Alberta Utilities Commission

Decision 23958-D01-2020

Alberta Health Services

Foothills Medical Centre Power Plant Expansion Project

Figure 1. Map of noise receptors

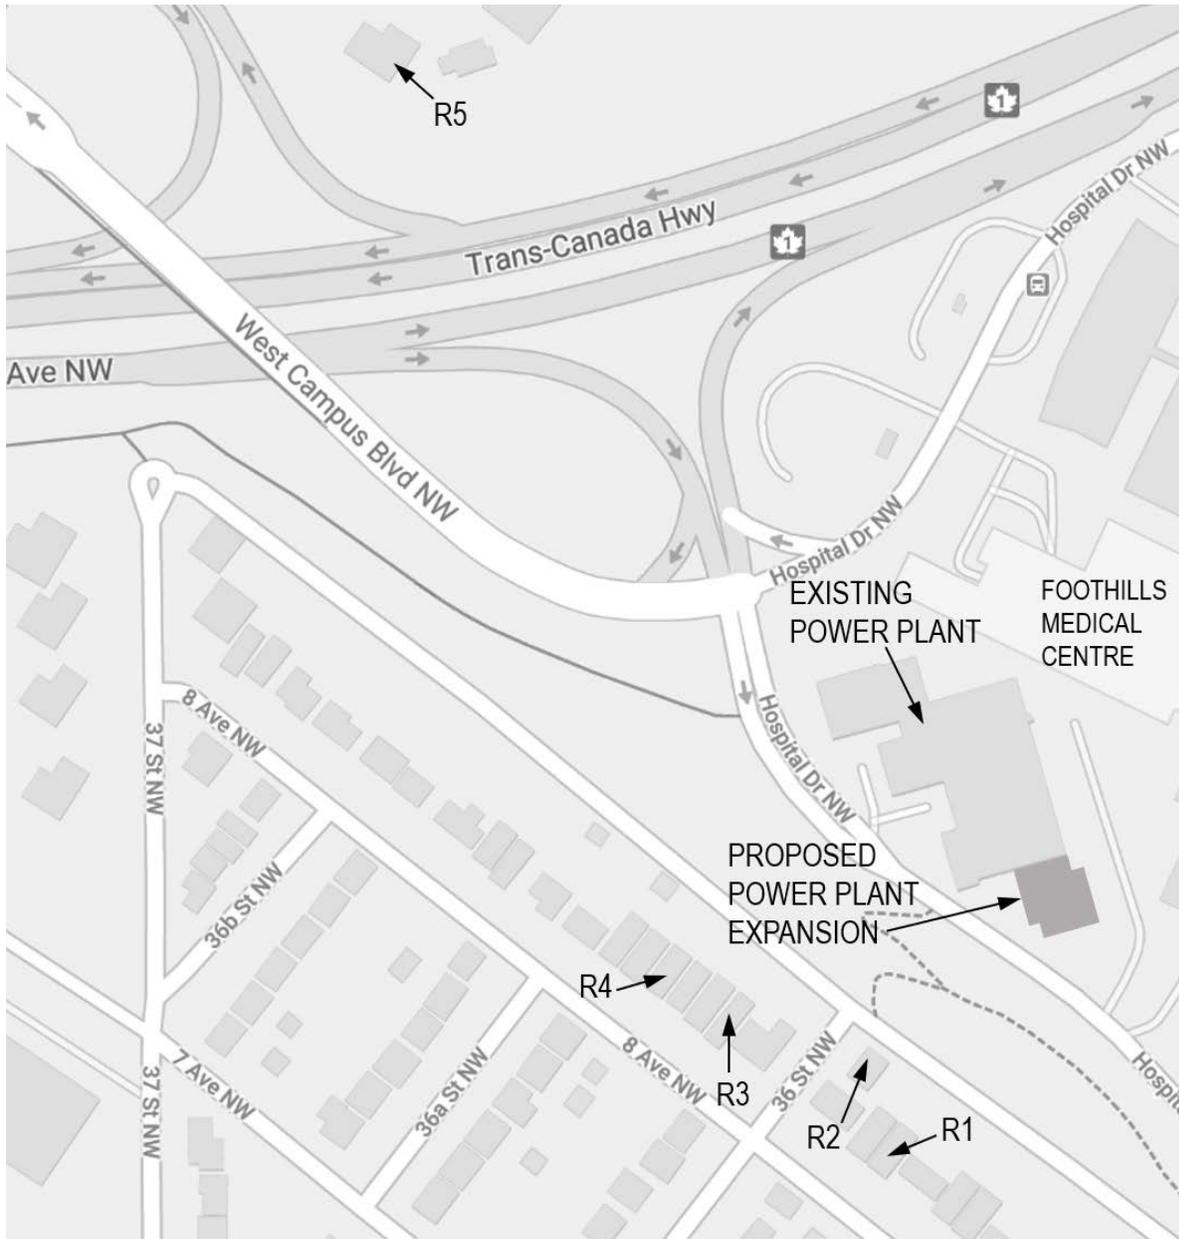
17. The project NIA included five dwellings as noise receptors, presented in Figure 1 below. Four of the receptors (R1, R2, R3, R4) are located in the community of Parkdale. The fifth receptor (R5) is located in the community of University Heights. The distances of each of the five receptors from the project are as follows:

- R1 – located approximately 68 metres from project
- R2 – located approximately 63 metres from project
- R3 – located approximately 69 metres from project
- R4 – located approximately 78 metres from project
- R5 – located approximately 250 metres from project
